University of Oregon's Oregon Bach Festival

City of Eugene Building and Permit Services Project Consultation Meeting Application

REVISED 11/23/2015

Proposed site plan showing re-configured Service Road and parking.

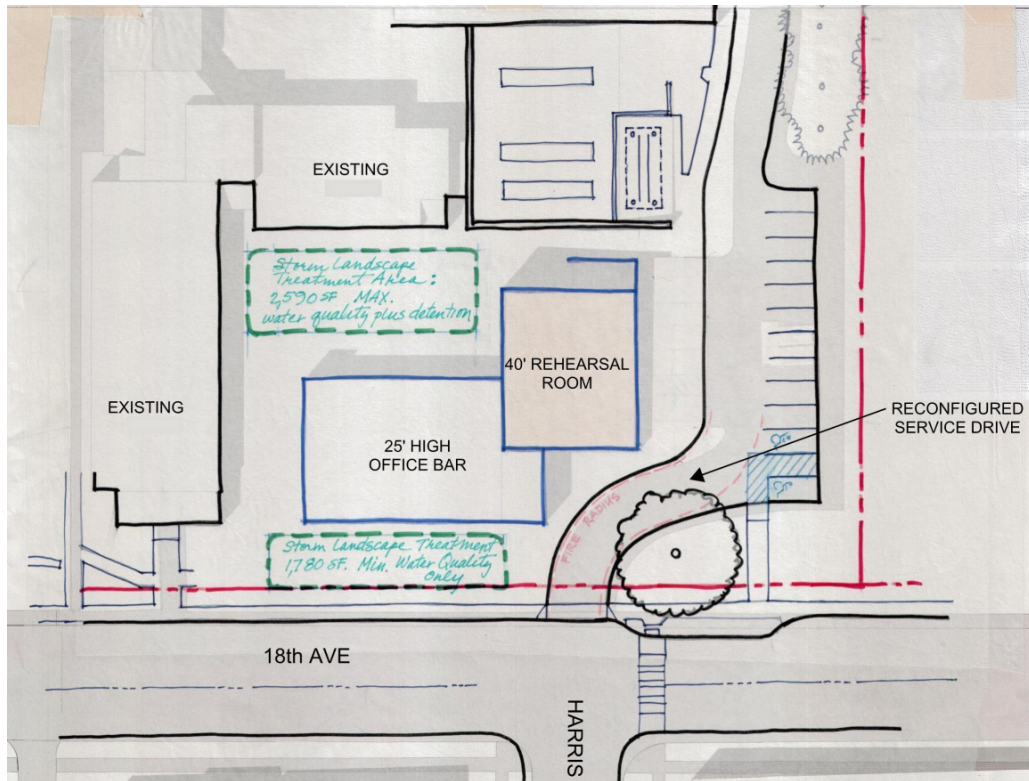
9. Service Road (continuance of Harris Street on UO campus: ideally this will be reconfigured along the lines of the attached sketch.

3. Assuming the Service Road alignment with Harris St is maintained in its current configuration, and the campus roadway reconfigured per the attached sketch, can the Fire Marshal give us preliminary approval for the proposed layout?

4. The new building will displace 18 existing parking spaces; the hope is to replace these and add up to seven additional spaces, located along the Service Road. One option is for these to be nose-in parking spaces; vehicles would reverse into the Service Road on departure. The Service Road is a fire lane. Is this basic strategy sound?

5. Please advise regarding the proposed location of accessible parking spaces
6. What would trigger a PEPI process for this project?
 - a. Prior question: [Can we create a dedicated on-street drop off zone on 18th Avenue? If so, how far from the Harris Street and service road intersection must this be? Can we do this in the currently yellow-painted curb zone in order to retain all on-street parking?]
